Access Compliance Report

Intersection ID: 6492	Main Street: OASIS_LN	Cross Street: BELMEADE_GREEN_DR	Location: SE
ADA ID: 26746E7CE0EF	Ramp Type: PerpDiag	Initial Pass/Fail: Fail	Overall Compliance: No
Severity Score: 12.5			
Codes/Mitigation Info/Possible Solution		Field Measurements/Component Compliance

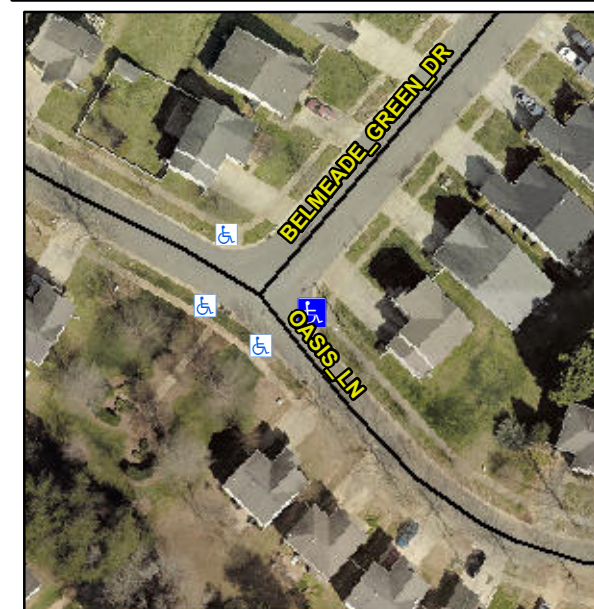
R304.5.3

Compliance	Description	Data	Compliance	Description	Data
N/A	Ramp Length (in)	83.0	Yes	Ramp Slope (%)	8.1
Yes	Ramp Width (in)	50.0	No	Ramp XSlope (%)	6.3
N/A	Flare Type LT	N/A	N/A	Flare Type RT	N/A
N/A	Flare Slope LT (%)	N/A	N/A	Flare Slope RT (%)	N/A
N/A	Flare Traversable LT?	N/A	N/A	Flare Traversable RT?	N/A
N/A	Landing Length (in)	N/A	N/A	DWS Provided?	N/A
N/A	Landing Width (in)	N/A	N/A	DWS Contrast?	N/A
N/A	Landing Slope (%)	N/A	N/A	DWS Length (in)	N/A
N/A	Landing X Slope (%)	N/A	N/A	DWS Full Width?	N/A
N/A	Landing Curb? (Y/N)	N/A	N/A	DWS Offset (in)	N/A
N/A	Shared Landing?	N/A			
N/A	Gutter Ponding?	N/A	N/A	Gutter Slope (%)	N/A
N/A	Gutter Lip Ht (in)	N/A	N/A	Gutter X Slope (%)	N/A
N/A	Painted X Walk1?	No	N/A	Painted X Walk2?	No
	X Walk 1 Direction	To NW		X Walk 2 Direction	To SW
N/A	X Walk 1 Width (in)	N/A	N/A	X Walk 2 Width (in)	N/A
	X Walk 1 Slope (%)	0.9		X Walk 2 Slope (%)	5.8
	X Walk 1 X Slope (%)	4.2		X Walk 2 X Slope (%)	3.0

Remove & Replace Curb Ramp With Two New Directional Ramps or Equivalent.
